## Contract Routing Form

Project: State St Reconstruction Assessment District-2014

Contract No.: 7206  
Enactment No.: RES-14-00333  
Dollar Amount: 4,733,488.80

1  
S-4  
STREETSCAPE PLAN - 700 BLOCK  
1"=20' @ 11X17

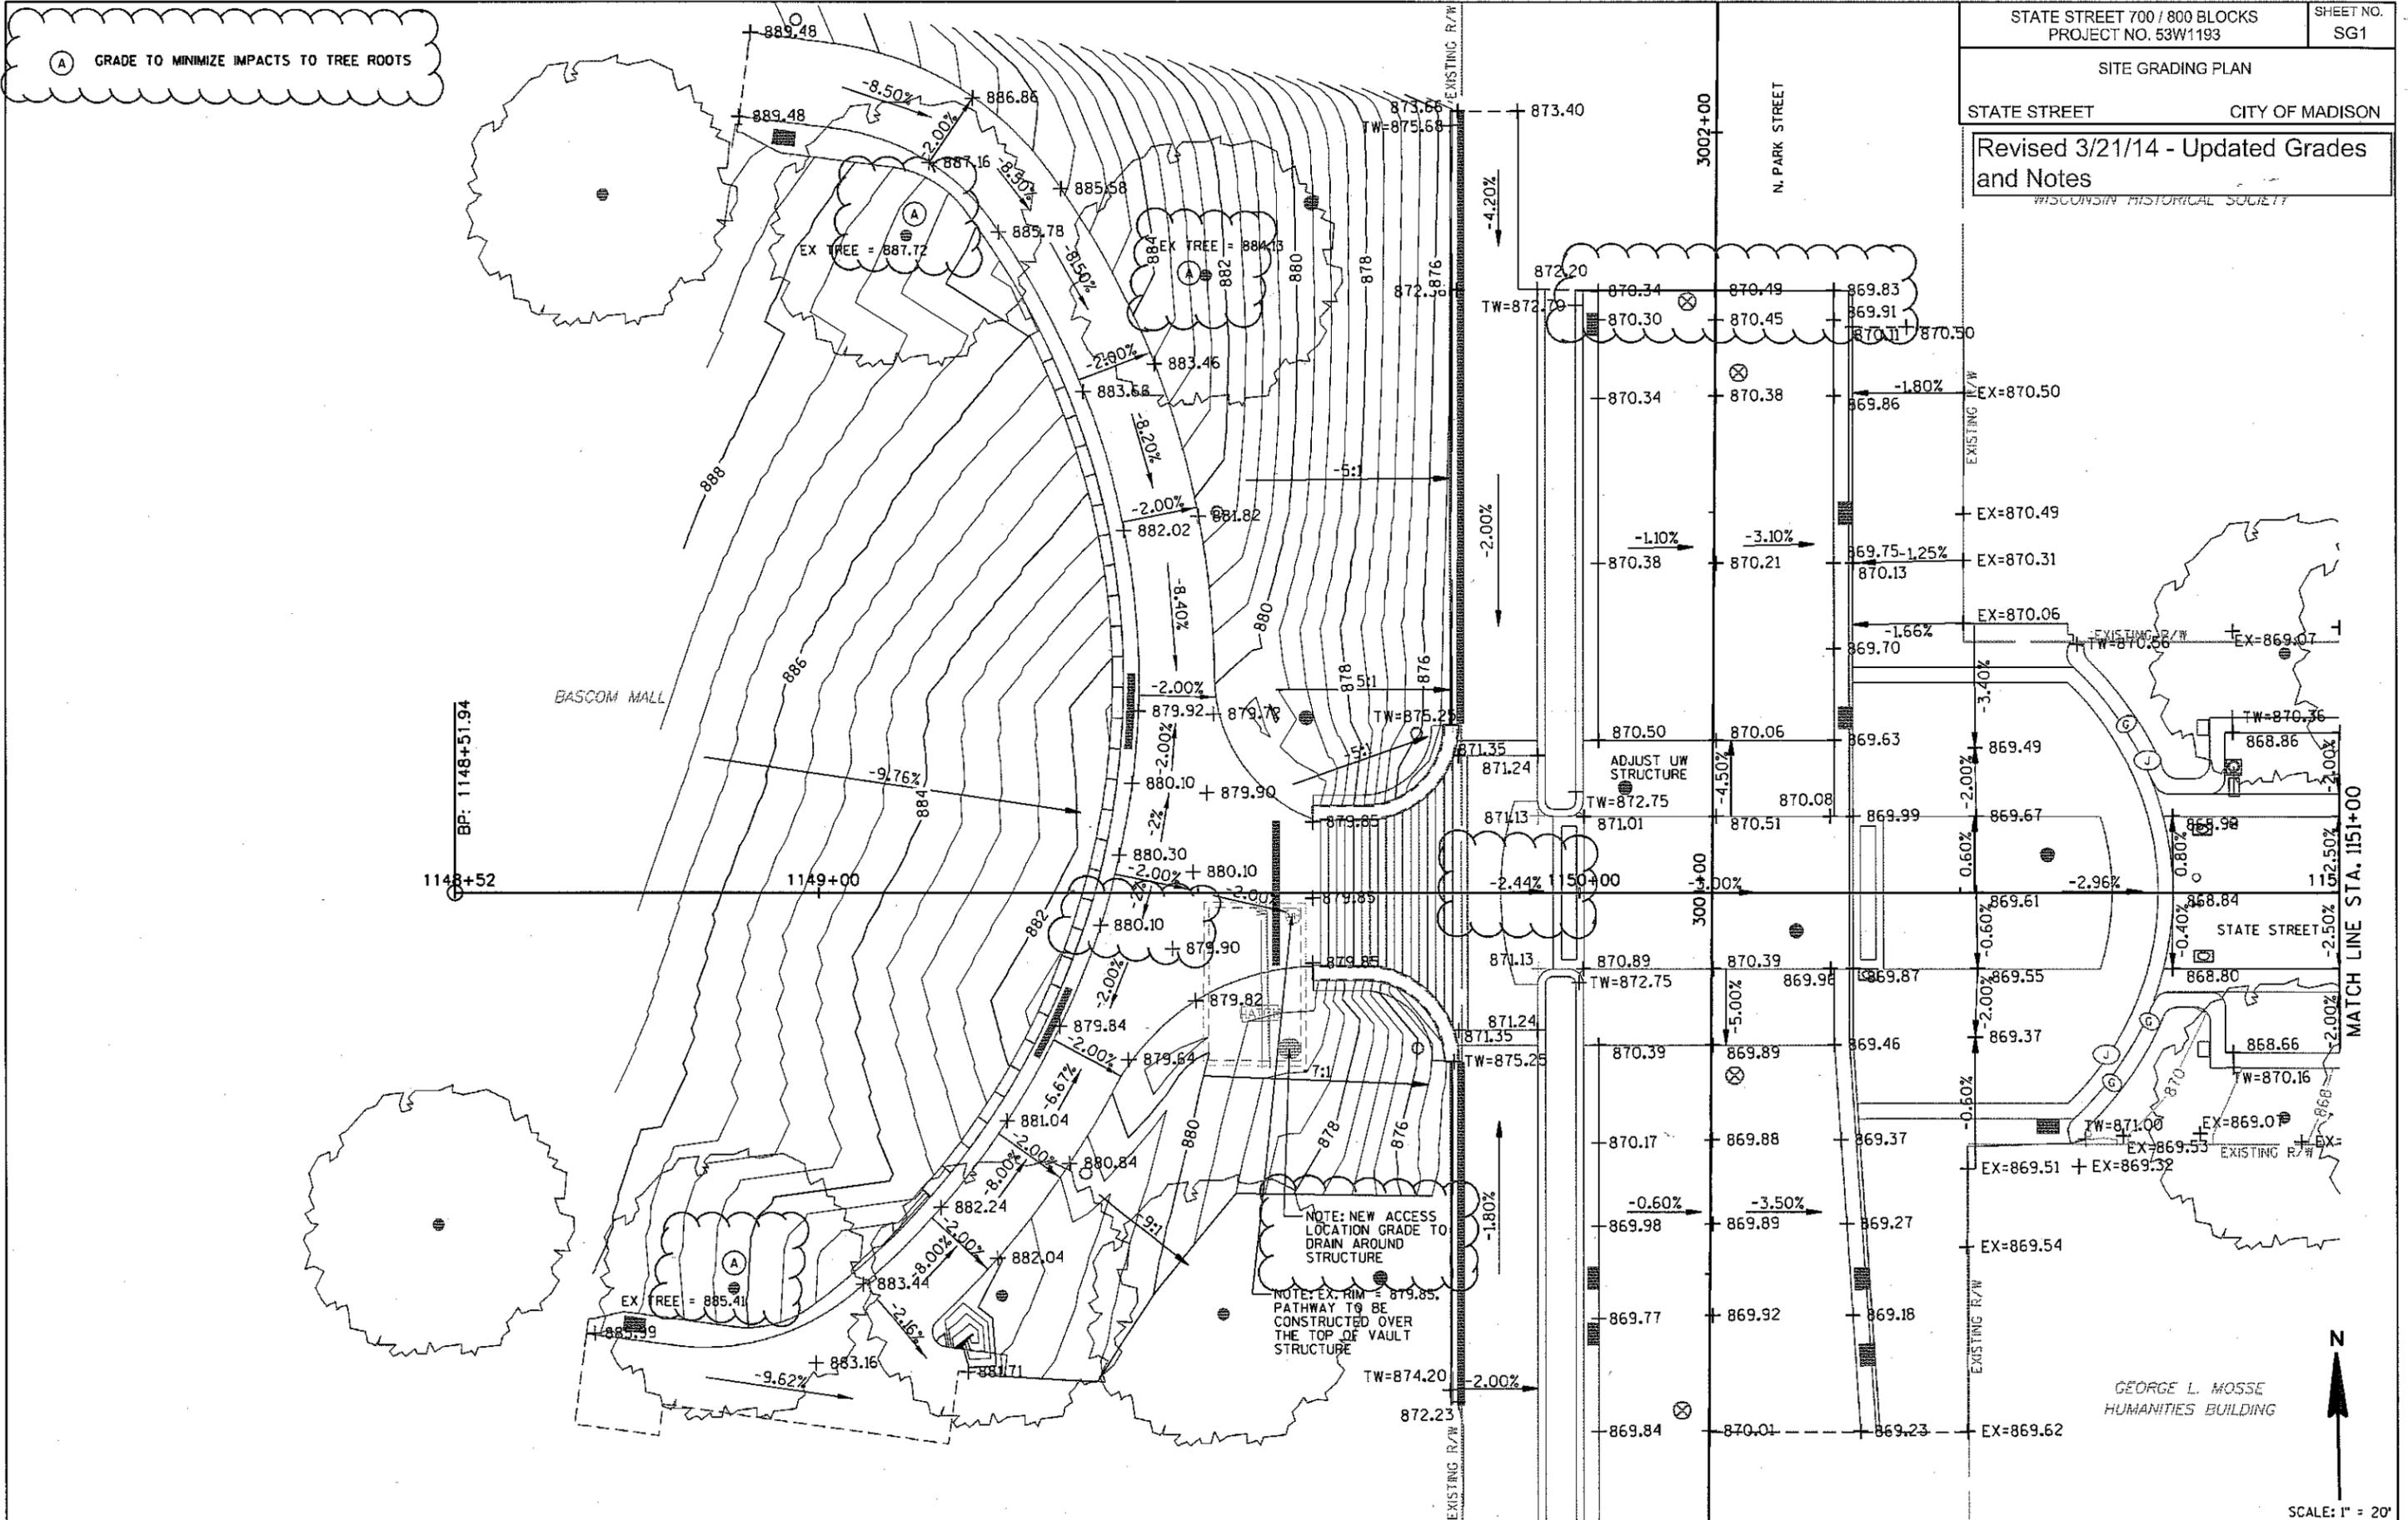
Replace Sheet S4 (Revised 3/21/14) – Added callouts for Seat Wall with Precast Cap in planter condition.

REINFORCEMENT PLAN - PEDESTRIAN LIGHT BASE OPENINGS

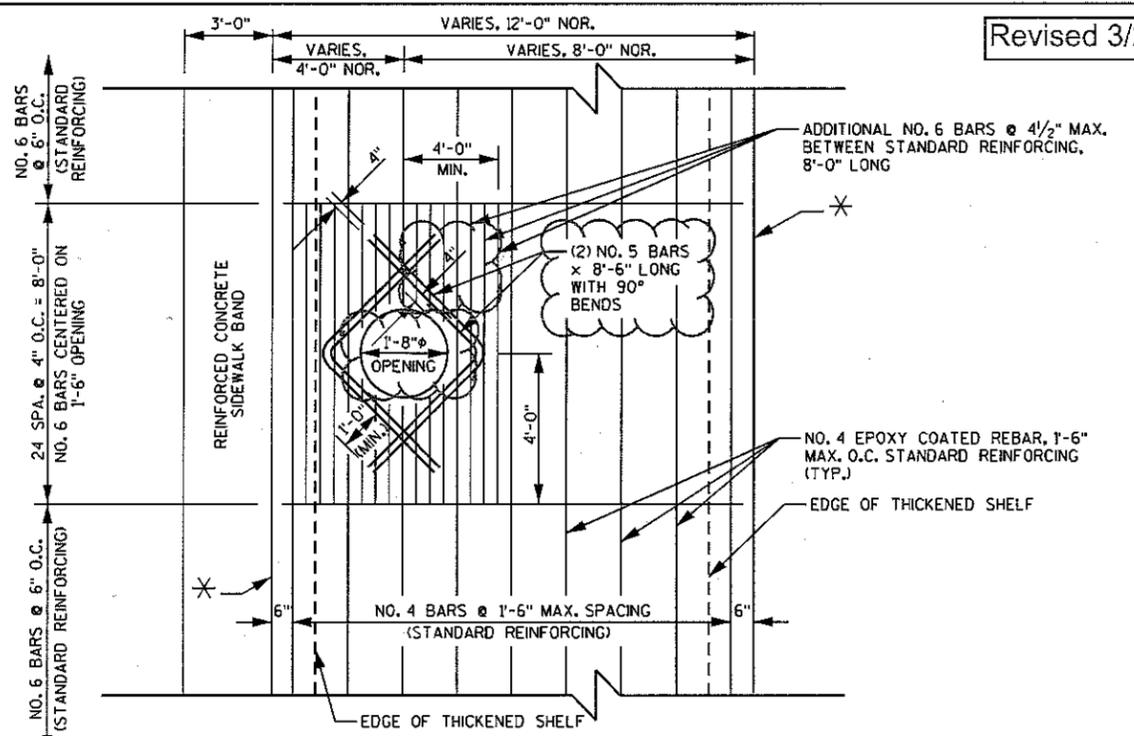
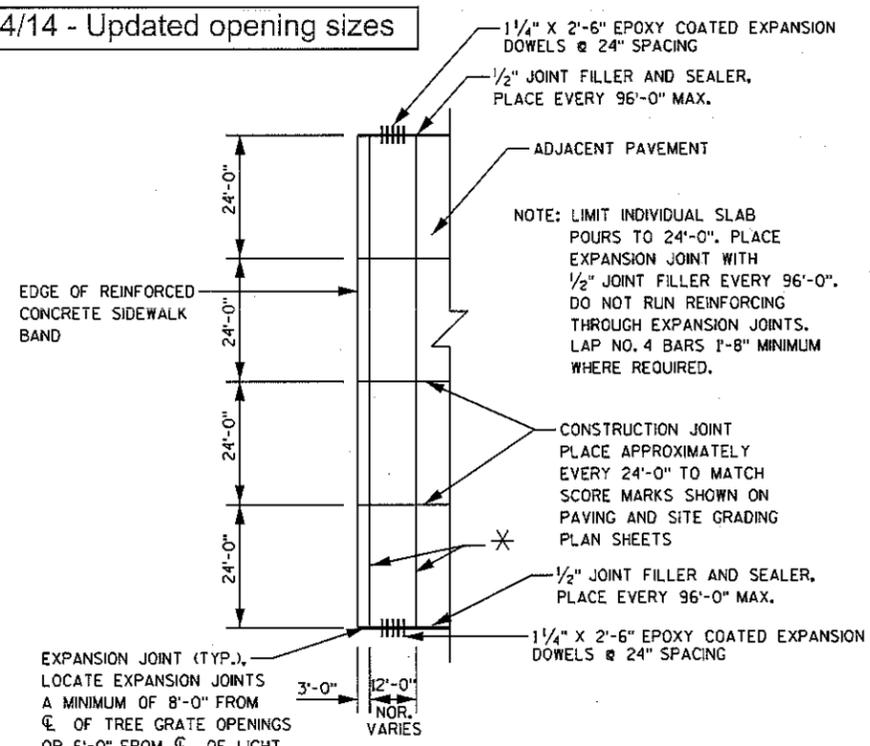
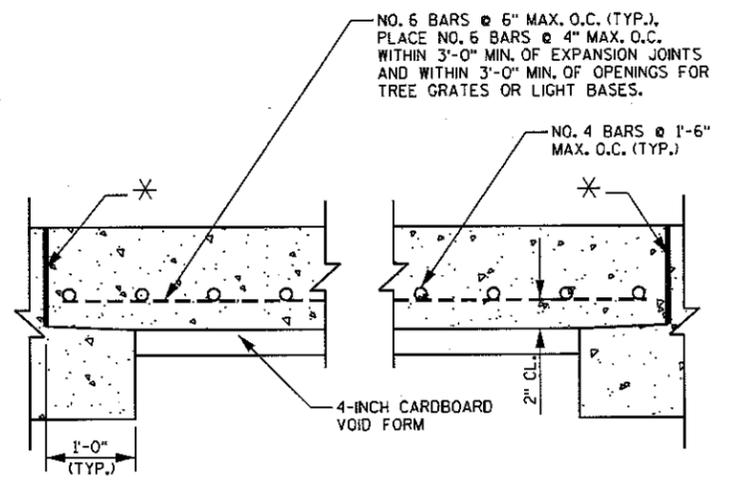
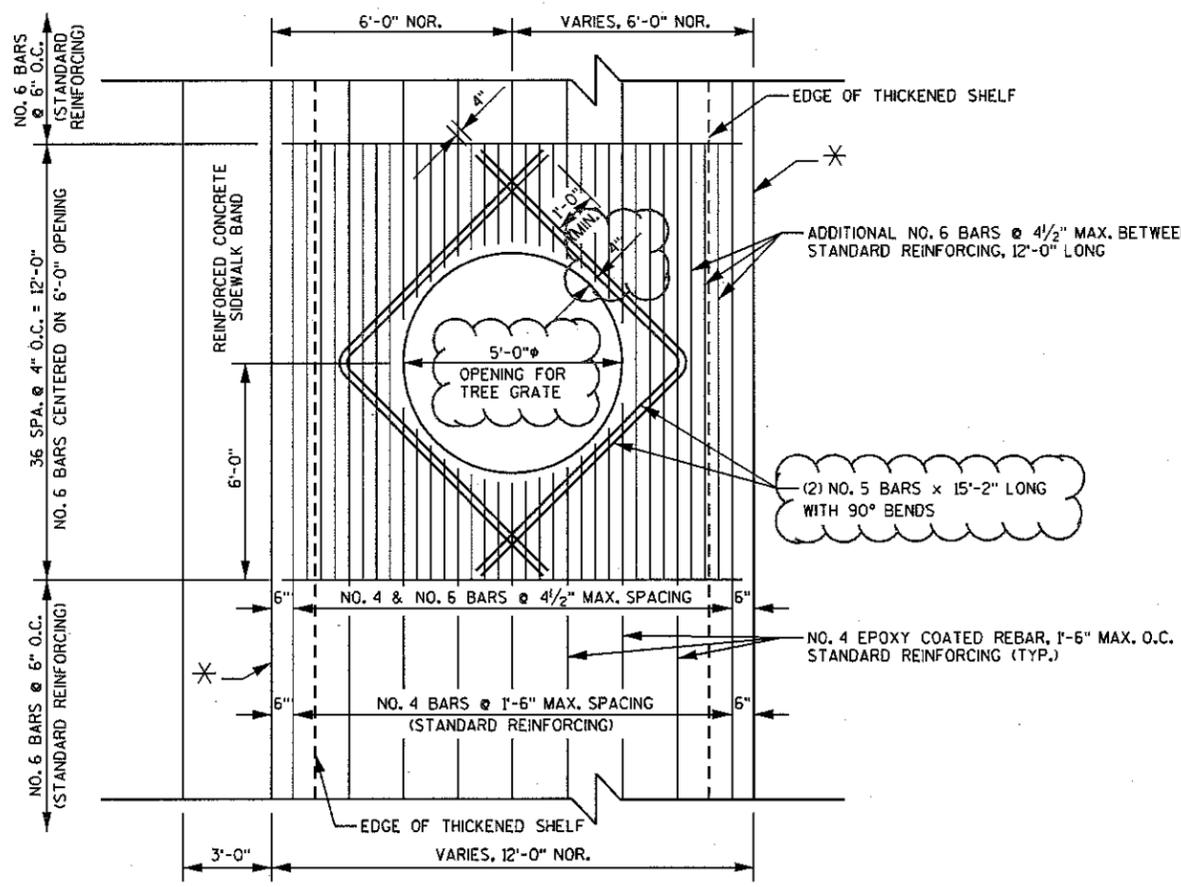
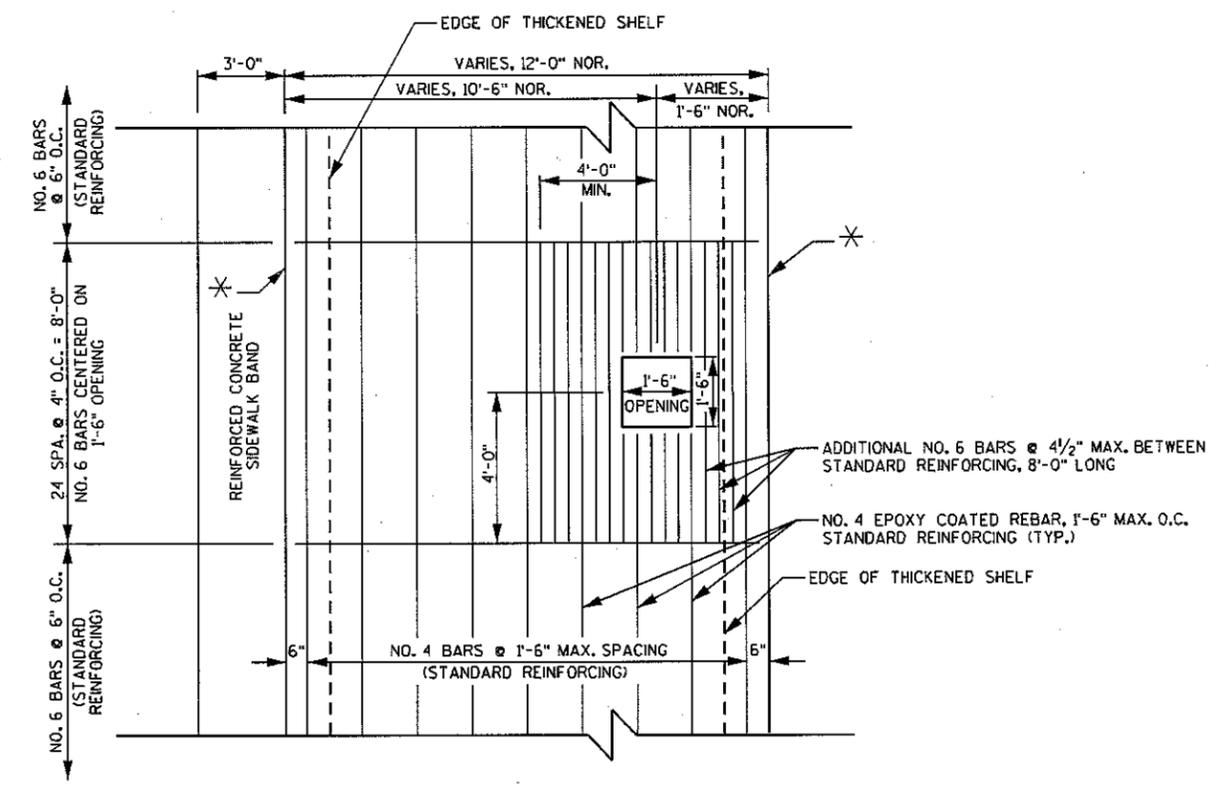
Replace Sheet P8 (Revised 3/24/14) – Updated opening size for pedestrian light and tree grate in tree pit slab.

Revised 3/24/14 - Updated opening sizes
